AGENDA ITEM #8

Consideration of Resolution 2021-34 approving the final plat for TP Grantsville, LLC and Shawn Holste on the Parkinson Meadows Subdivision for the creation of thirty-six (36) lots in the R-1-21 zone.

Project Memorandum

To Kristy Clark, Grantsville City Planning and Zoning Administrator
From Shay Stark, Contract City Planner
Date April 7, 2021 Updated May 6, 2021 
CC
Subject Parkinson Meadows Subdivision Final Plan – 3rd Review

DATE: 05/15/2021
 SHEET 1 OF 2

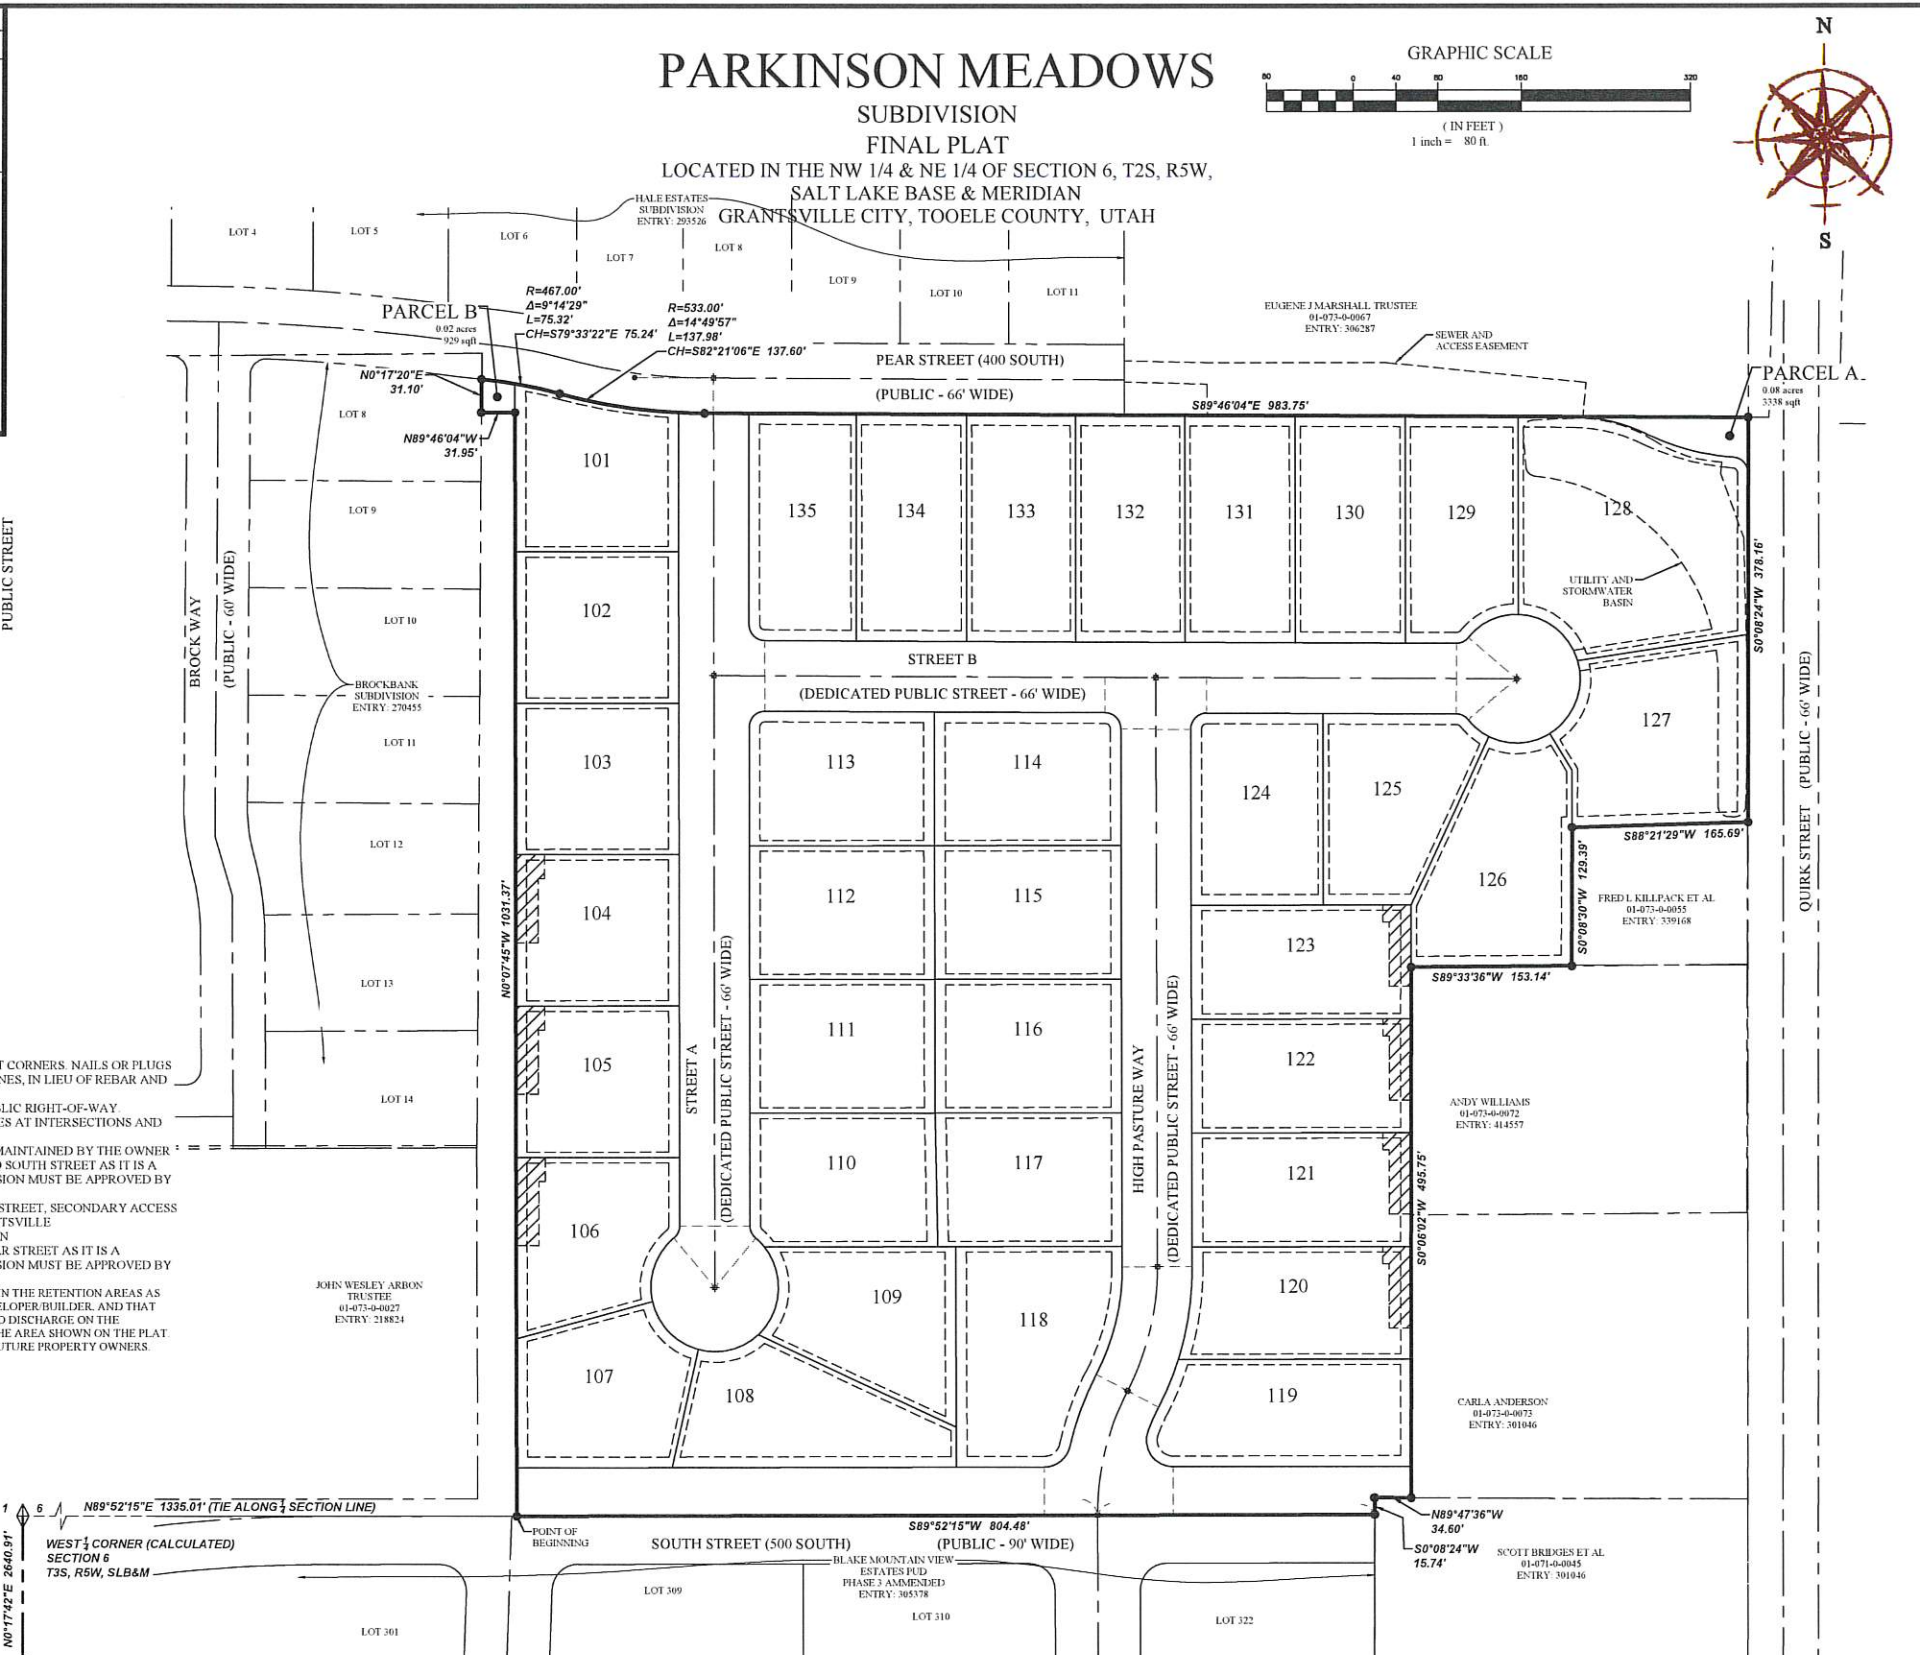
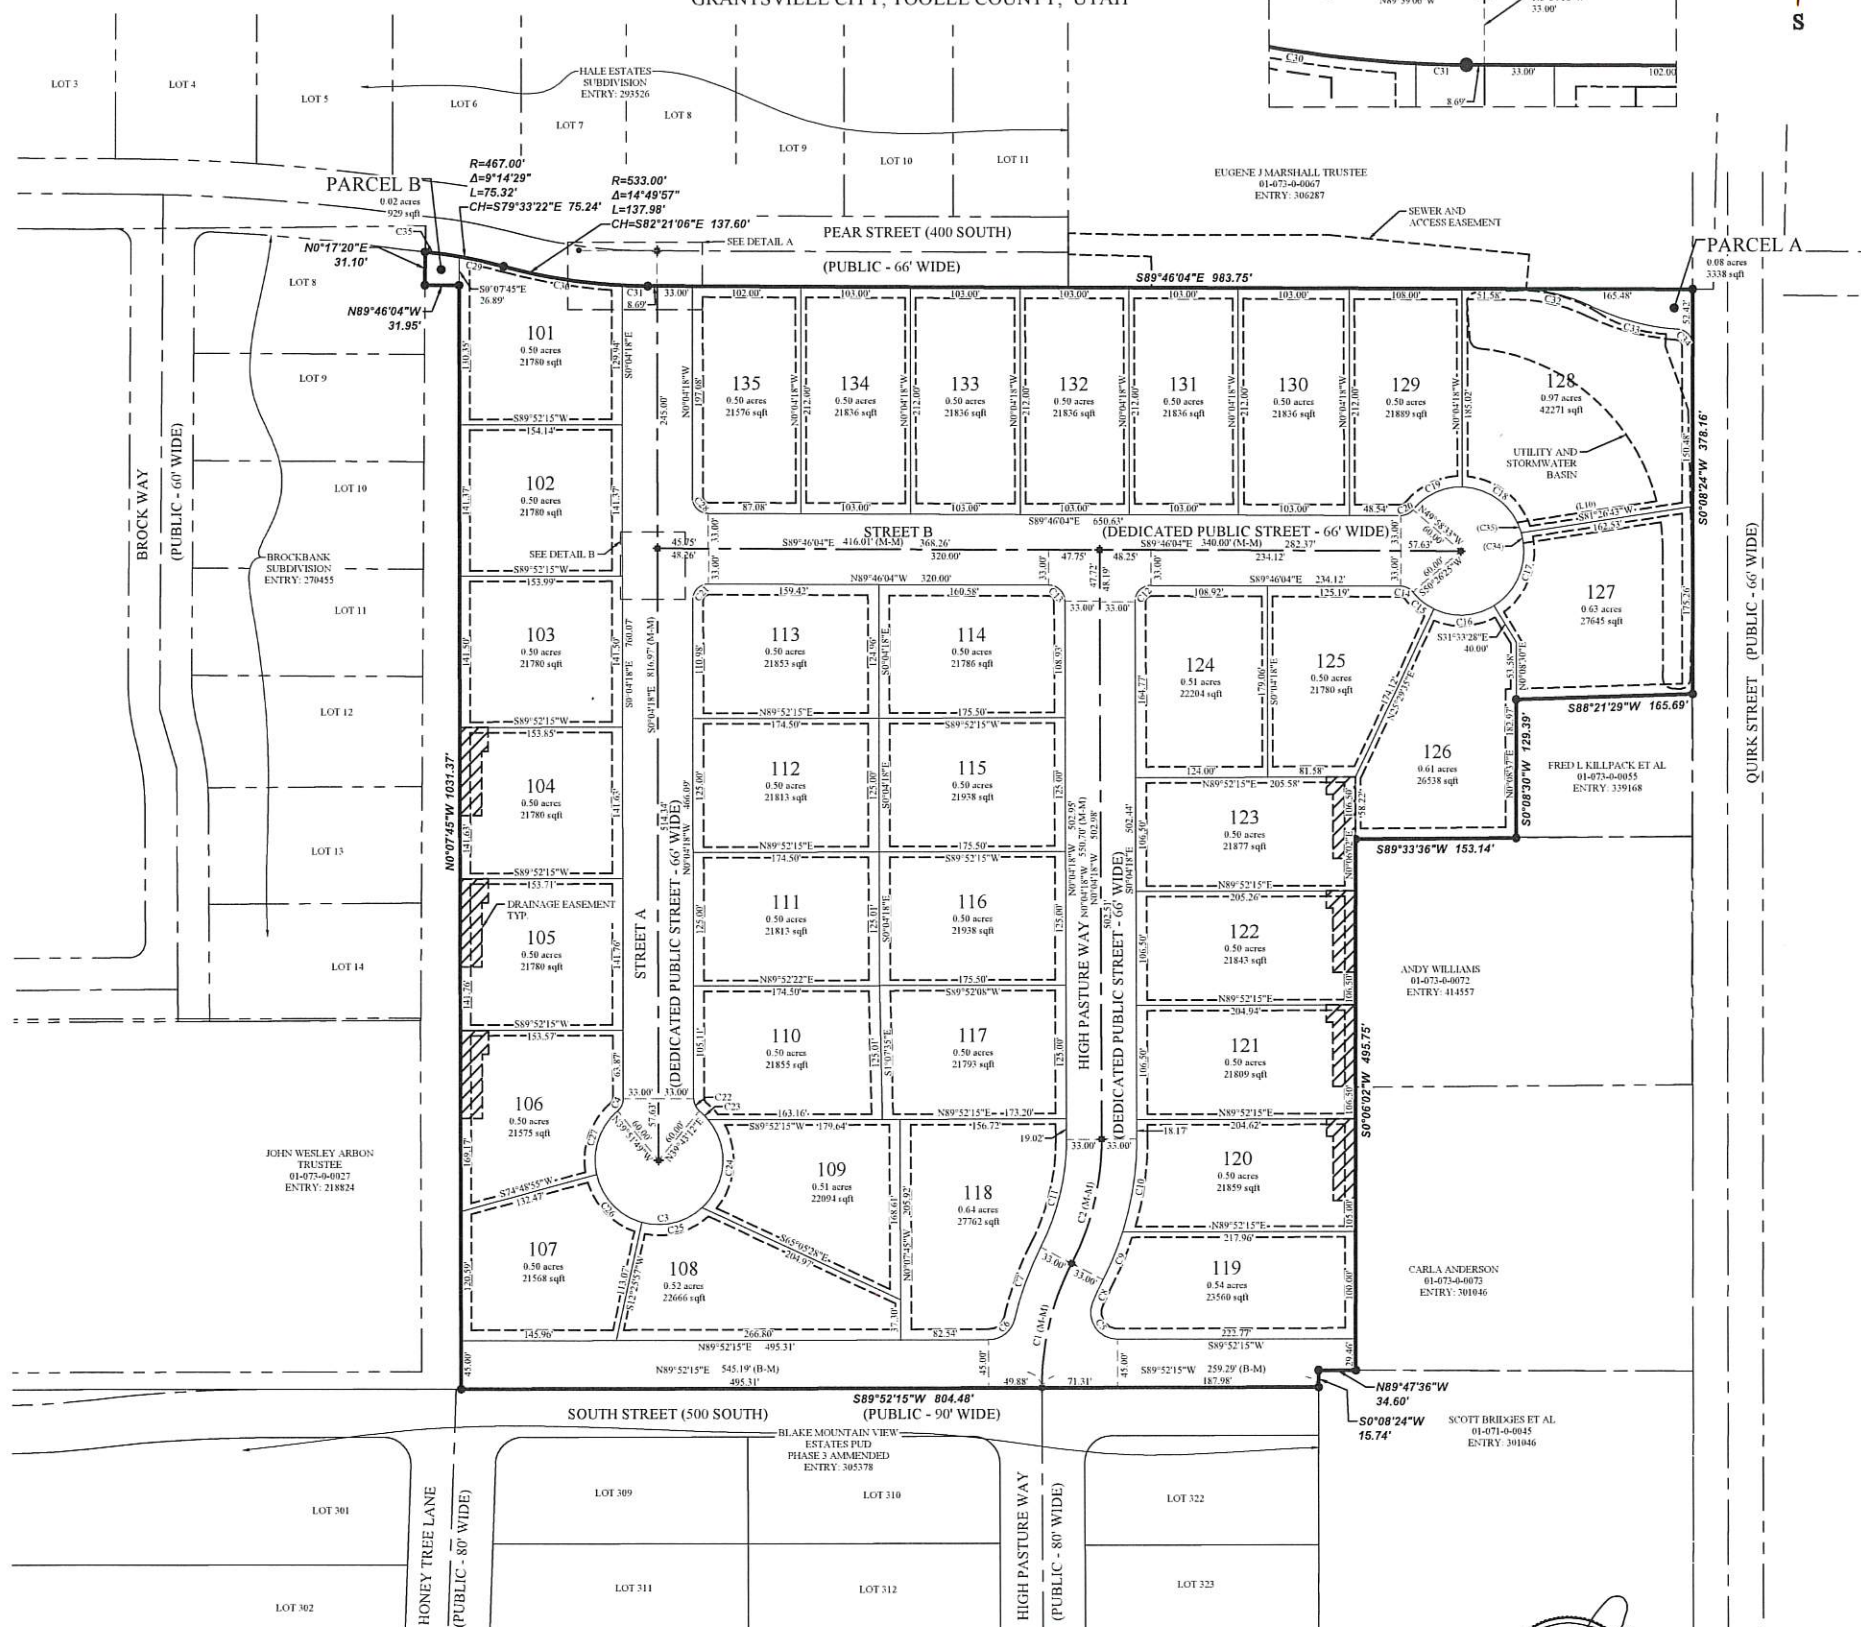
- Notes 6 and 3 on the Plat are the same. Lot numbers don't exactly line up with streets. See Gary's comments. Sheet C2 the first Plat up by the compass symbol. (Complete)
- Clean up notes. (Complete)
- **The street needs to be renamed South Street not Hale Street. This also effects Note 5 on the Plat.**
- **The names of the new streets need to be called out on the plat with the language: Dedicated Public Street underneath.**
- **Put a note on Plat stating: No animals can be kept in stormwater basins.**

10. NO ANIMALS CAN BE KEPT IN STORMWATER BASINS.
 11. SEE SHEET 2 FOR LOT DETAILS.

Scale: 1"=60'
Date: 5/4/2021
Sheet: C3

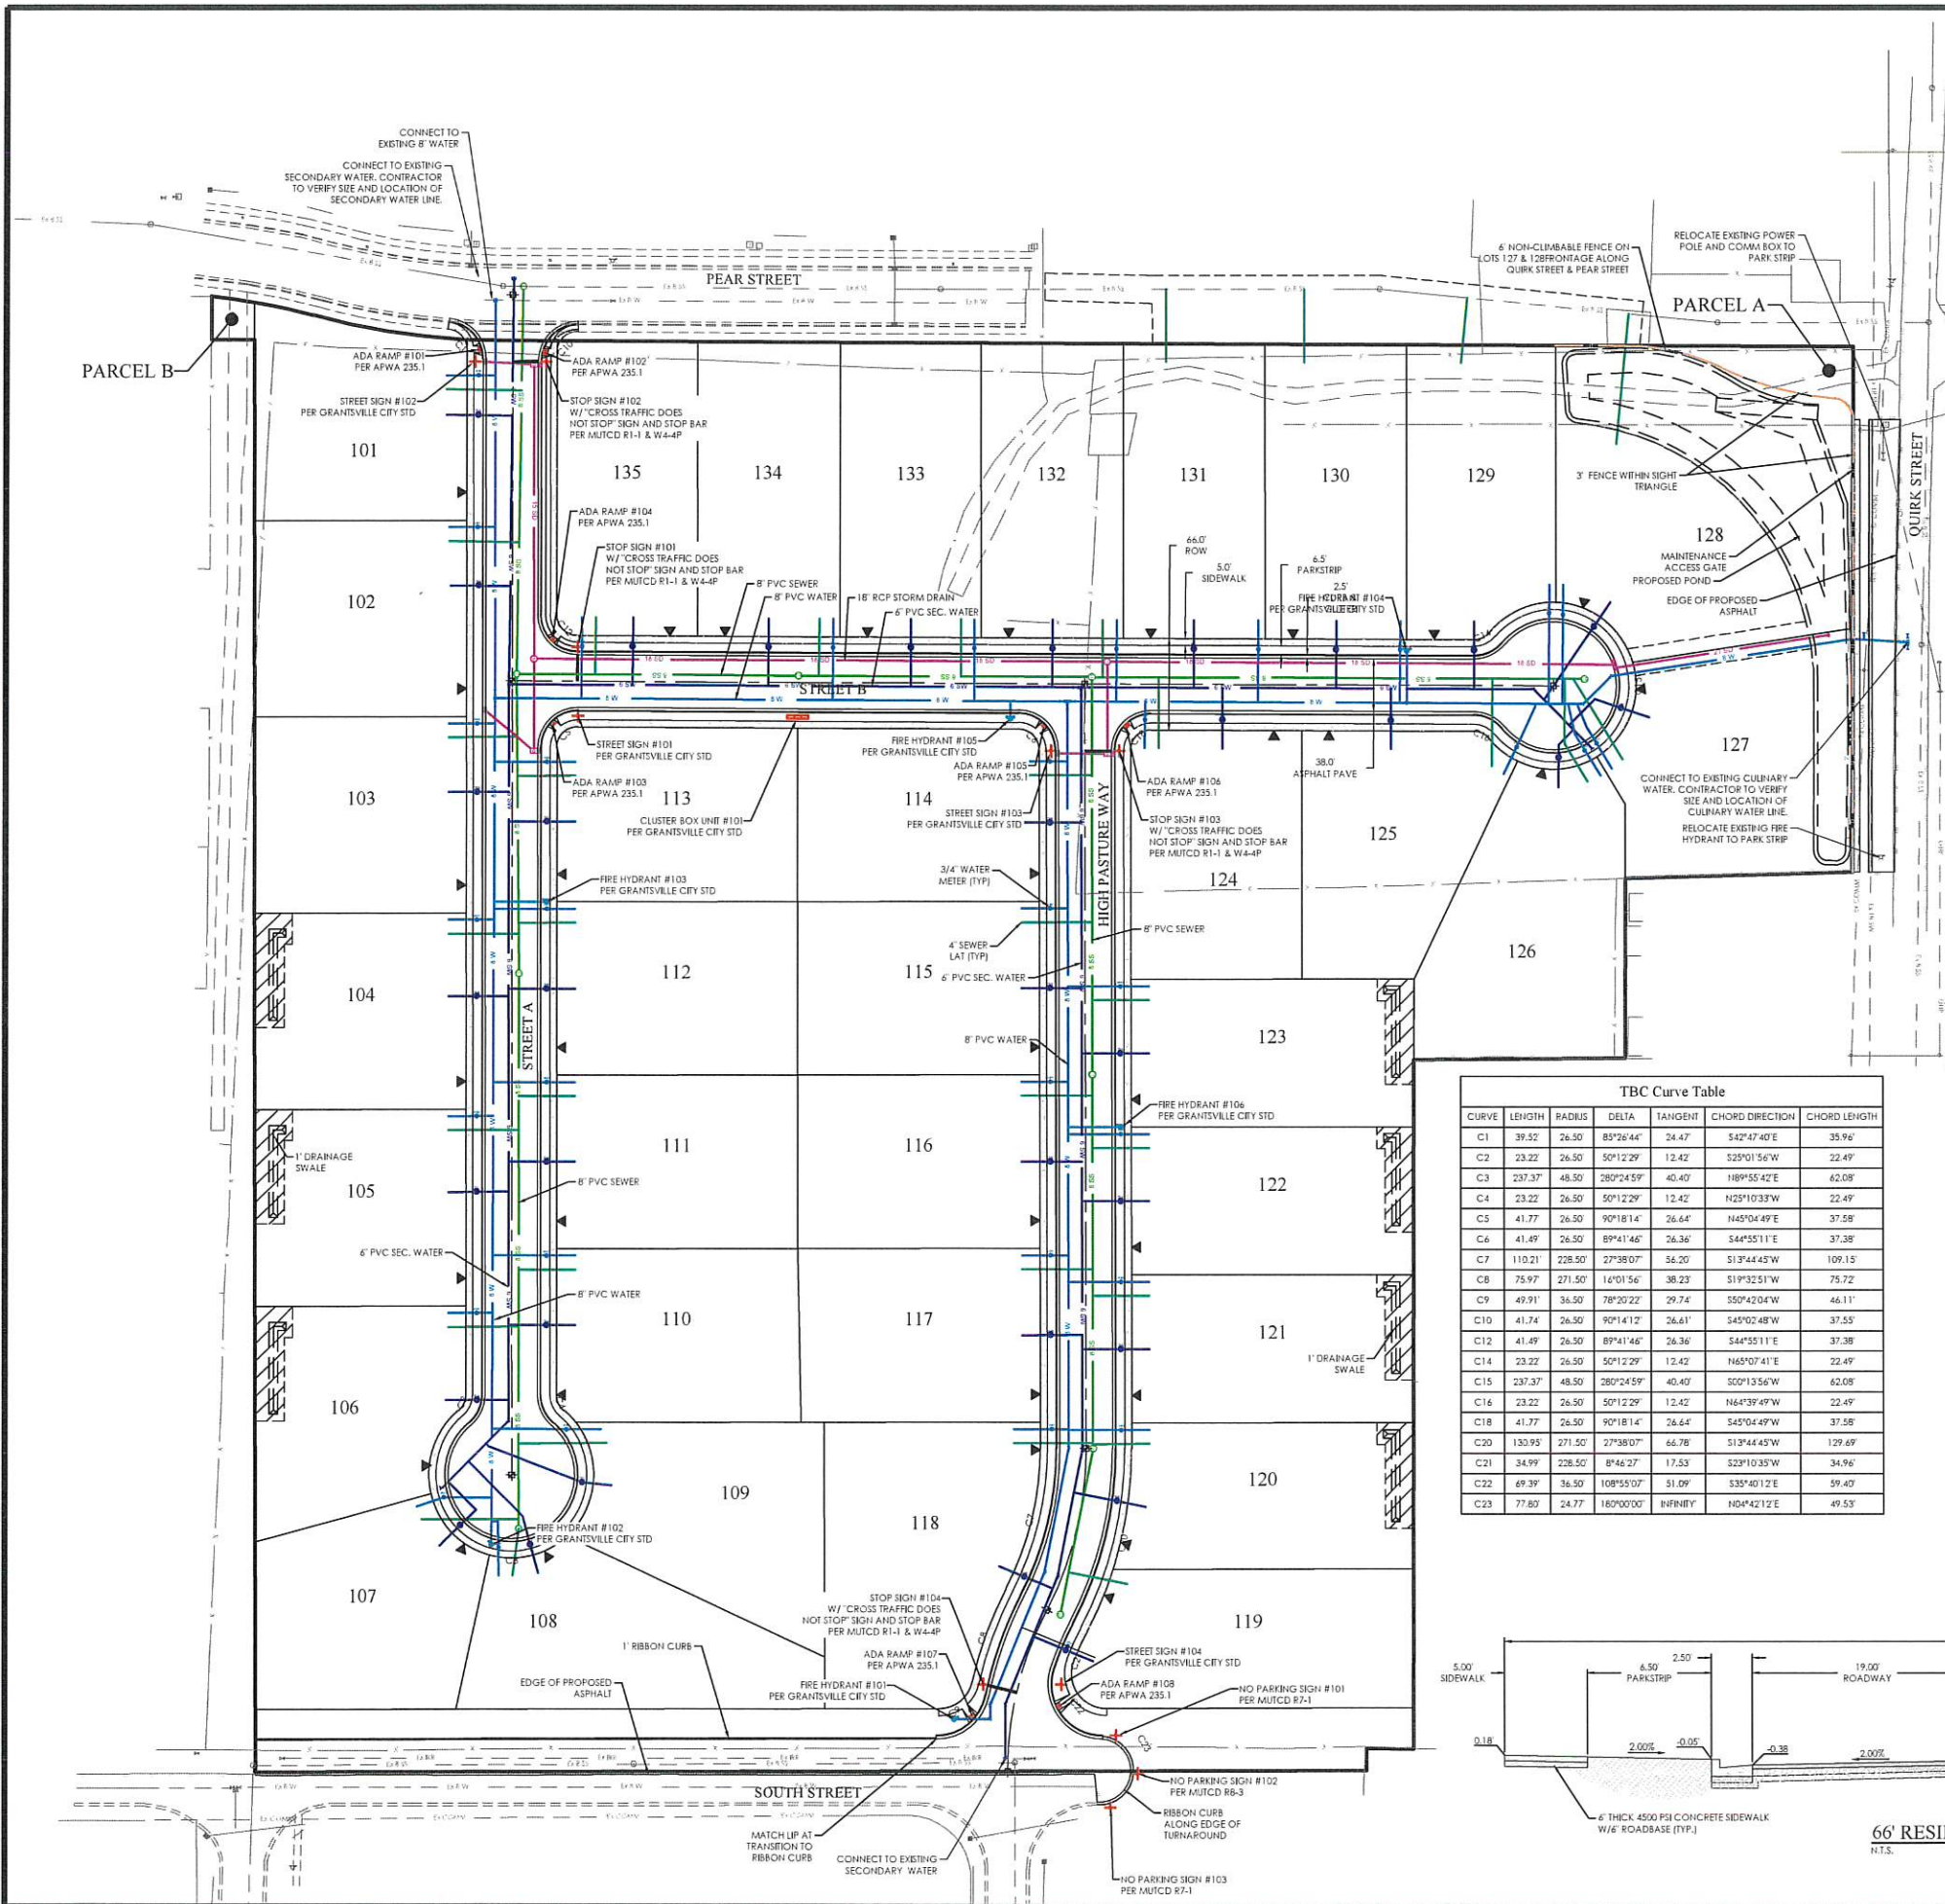
In the 3rd submittal review memo dated May 6, 2020, (orange comments) and found in the supporting documentation attachment. All of the engineering issues have been addressed and the drawings are complete with the exception that Street Names have not been added to two of the interior streets. Those streets now labeled "Street A" and "Street B" will require appropriate street names before the application can be approved by City Council.

Revised drawings based upon the staff review comments have been submitted to the City. The revised drawings are complete and have addressed the comments submitted to the applicant with the exception of the street names. "Street A" and "Street B" are not acceptable street names and must be changed on all drawings before final approval by City Council. The project is ready to move forward for consideration.
